REMARKS

ANNOTATED VERSION OF MODIFIED CLAIMS TO SHOW CHANGES MADE

FIG. 5

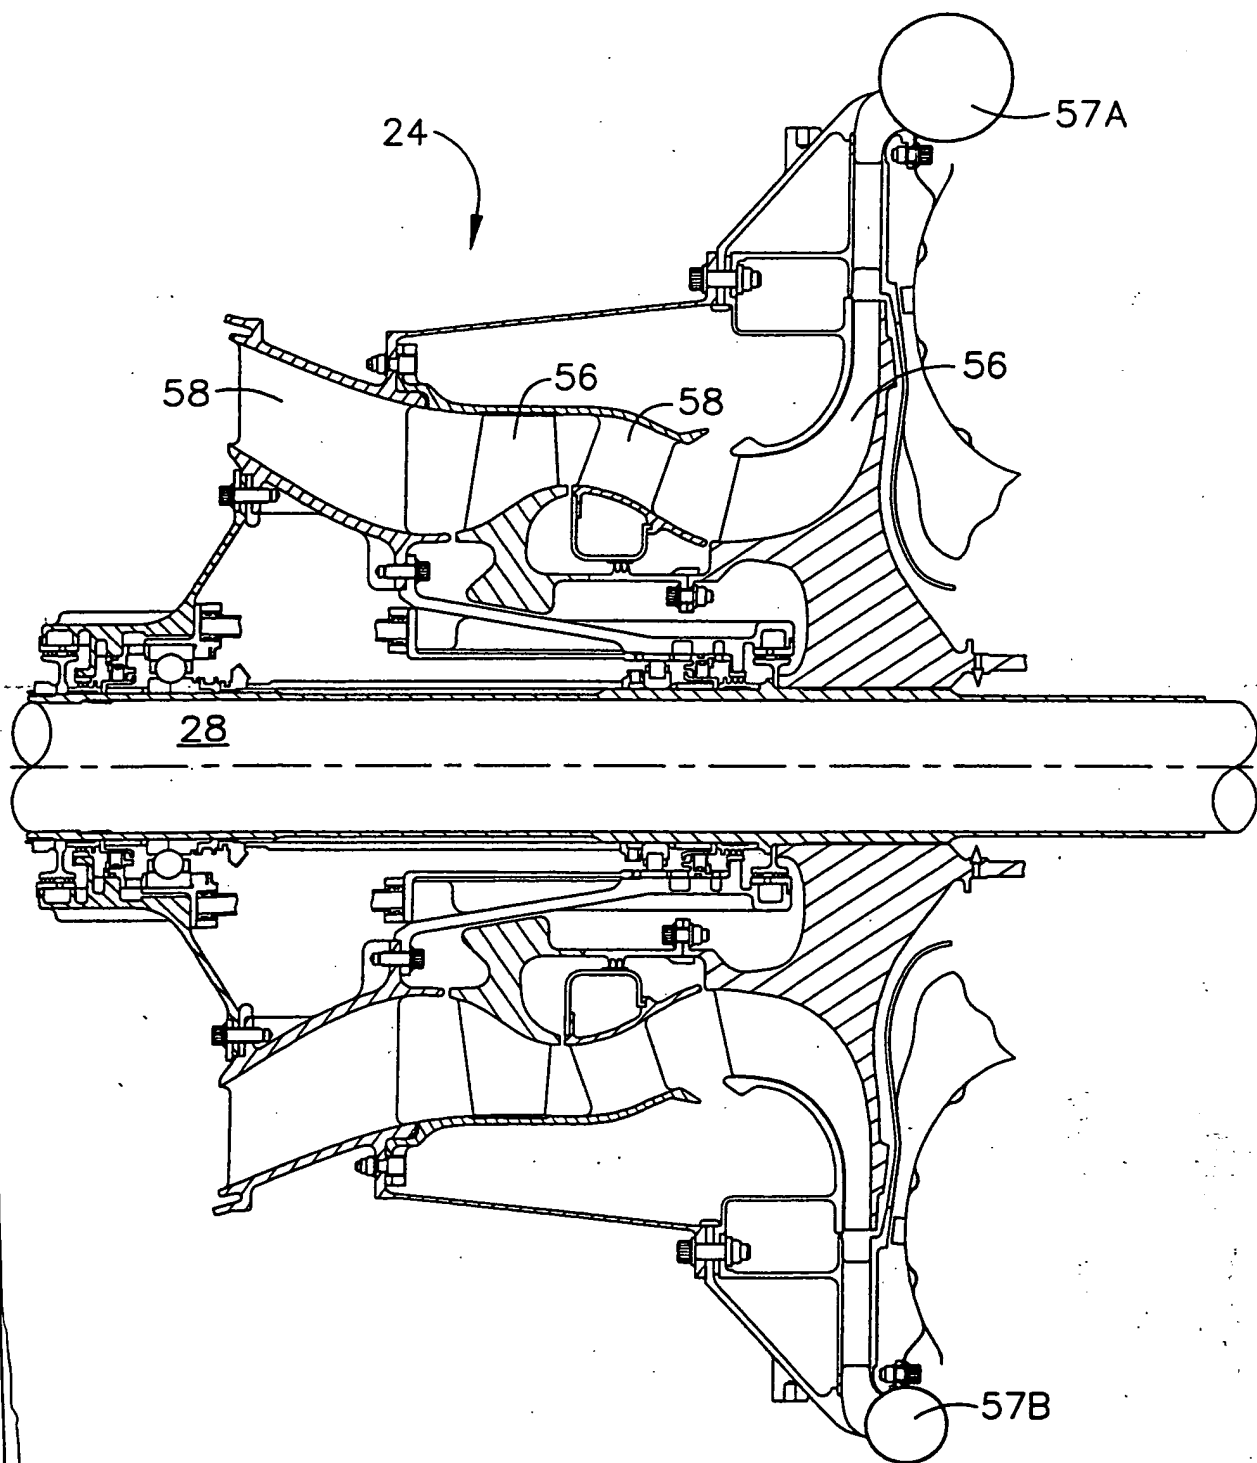
FIG. 5 has been cancelled and new FIG. 8 has been submitted in schematic form as suggested by the Examiner. The specification has been amended as required by the Examiner to delete the language about two rotating disc. Number 56 and 58 have been deleted from the specification as they are not included in the new FIG. 8. By deleting the new matter, the reissue Declaration is no longer defective. An executed Declaration that the original patent was lost is enclosed.

[FIG. 5 is a cross-sectional view of the compressor of the destruction device of FIG. 2;]

CANCELLED

FIG. 8 is schematic drawing of a two stage compressor of the destruction device of FIG. 2.

As discussed briefly above, compressor 24 suitably comprises the compressor of power generator 12. With momentary reference to the FIG. 8, compressor 24 preferably comprises alternate respective sets of rotating blades and stationary blades. Rotating blades are suitably rotated through rotation of shaft 28, which is briefly noted above, is initially activated by generator 20. In accordance with a preferred aspect of the present invention, compressor 24 comprises a multi-stage compressor, more preferably a two stage compressor.
